Staff Data Requests

I. **Wooster Renewable Energy, LLC, Case No. 14-2253-EL-REN**

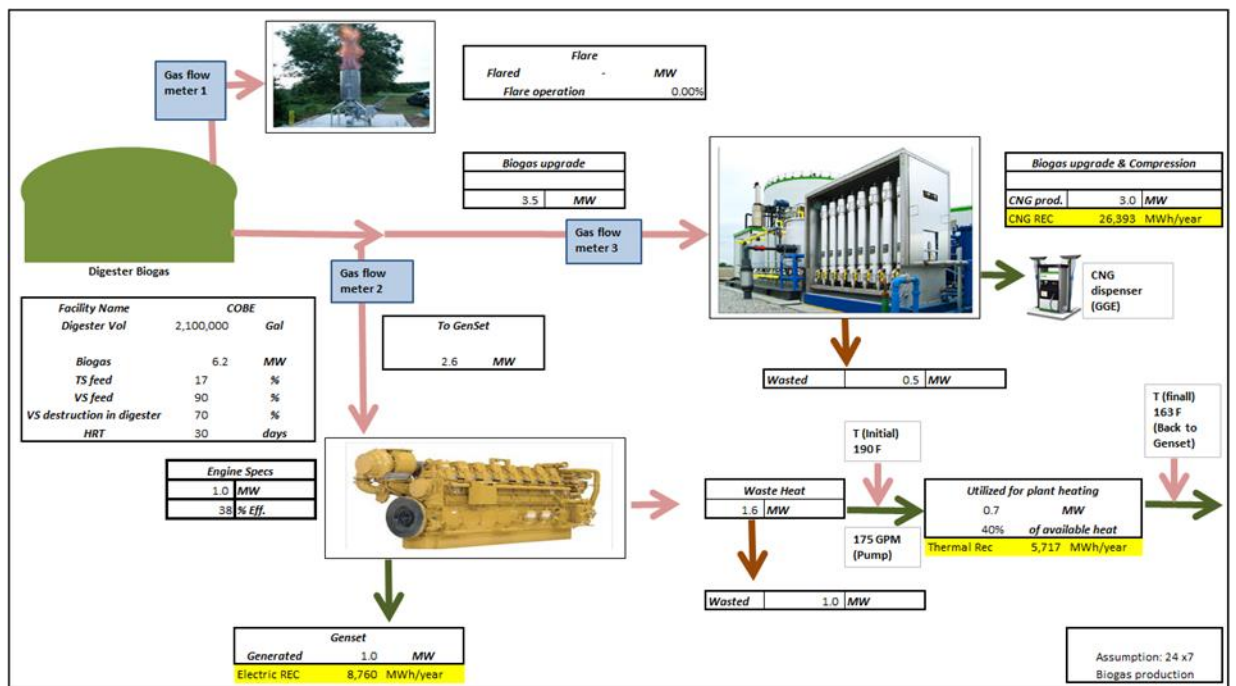
12. Regarding Section G.3 of the application, please provide a detailed description of how heat captured by each source is going to be measured and verified, including the configuration of the meter(s), the meter types(s), and meter accuracy. What is the projected in-service date of the thermal meters? Please provide documentation.

Thermal REC: Engine is cooled using a heat loop which circulates Glycol-Water mixture (50%) across the plant. The flow of the glycol is **175 GPM** (Pump rating, see fig.).

We have temperature sensor located in the engine which show the temperature of glycol taking waste heat from the engine. **The temperature is typically around 190° F (See fig. 1)** This glycol flows in the plant supplying heat for plant purpose (Digester heating, Floor heating, Pasteurization). **The return temperature of glycol is around 163° F (See fig. 1)**
